Subject: Issuance of Amendment No. 27 to Facility Operating License NPF-12 Virgil C. Summer Nuclear Station, Unit No. 1

AMENDMENT TO FACILITY OPERATING LICENSE

Amendment No. 27
License No. NPF-12

SAFETY EVALUATION BY THE OFFICE OF NUCLEAR REACTOR REGULATION

FIGURE 3.9-1 MINIMUM REQUIRED FUEL ASSEMBLY EXPOSURE AS A FUNCTION OF INITIAL ENRICHMENT TO PERMIT STORAGE IN REGION 2

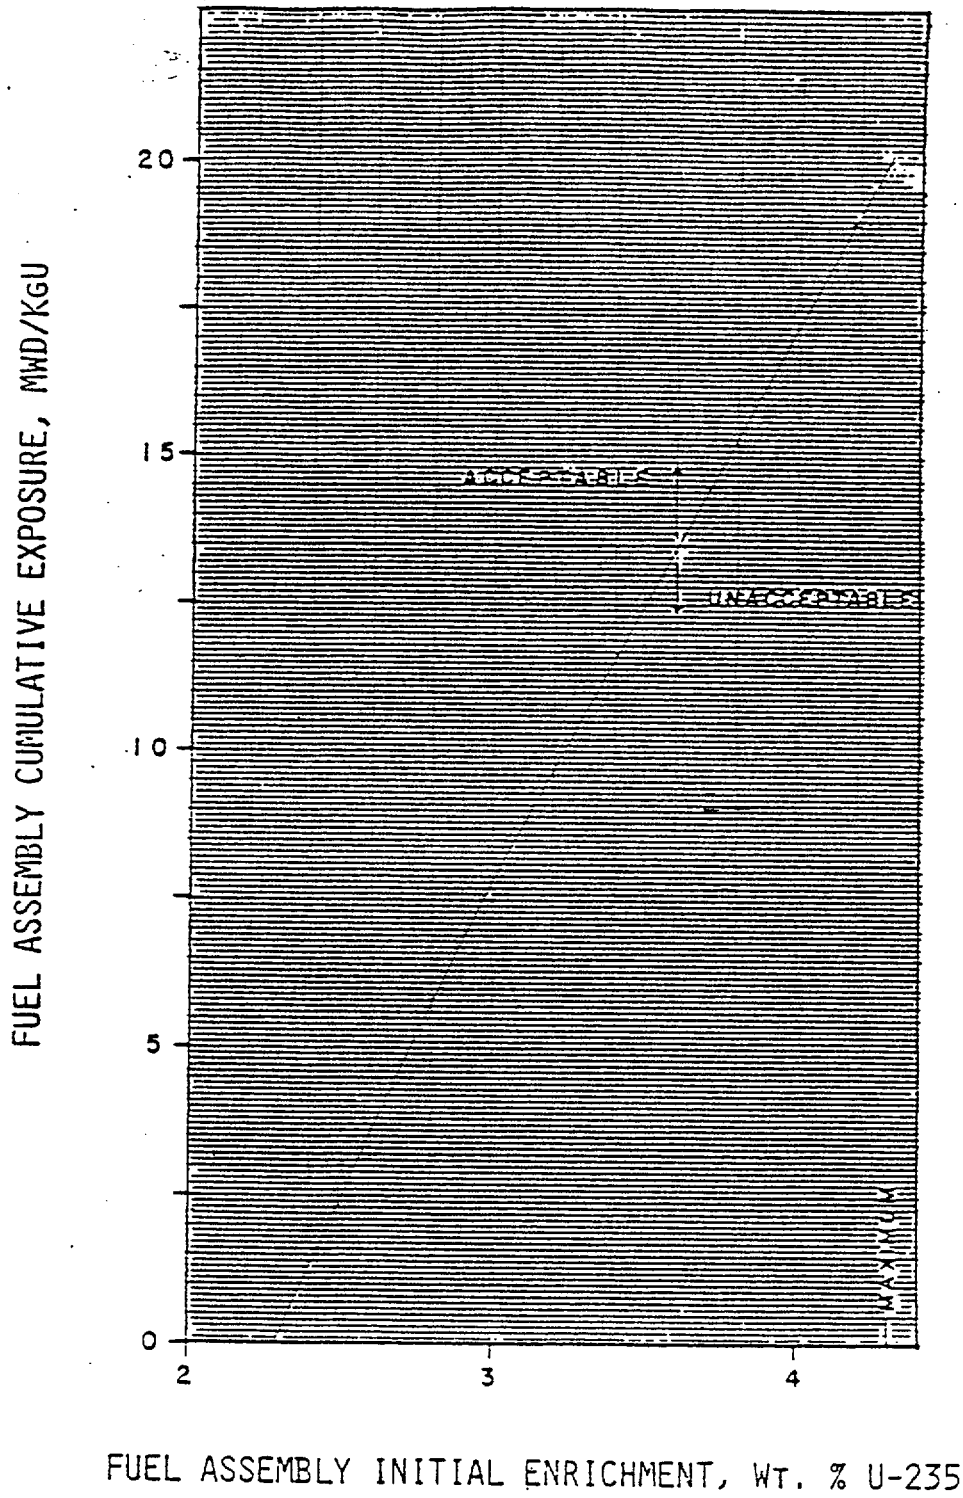
3.9.12 The combination of initial enrichment and cumulative exposure for spent fuel assemblies stored in Regions 2 and 3 shall be within the acceptable domain of Figure 3.9-1 for Region 2 and Figure 3.9-2 for Region 3.
